Product Change Notification

1. ECR #: 187852
Notification #: 488

3. Series:
• LSHM - 0.50MM TERMINAL/SOCKET COMBO

4. Part #'s Affected
• LSHM-1XX-XX-X-DH-A-S-K-TR

Existing design - Front view

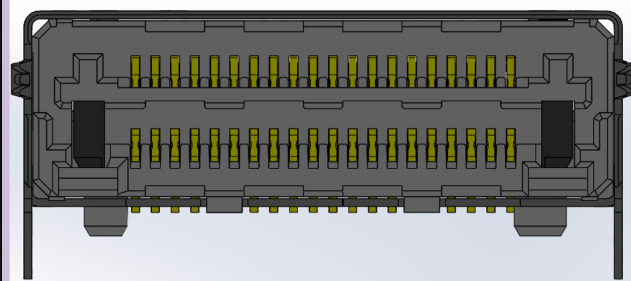
5. Description of Change:
Adding a weld tab to the assembly on both sides and removing the feet from the shield.
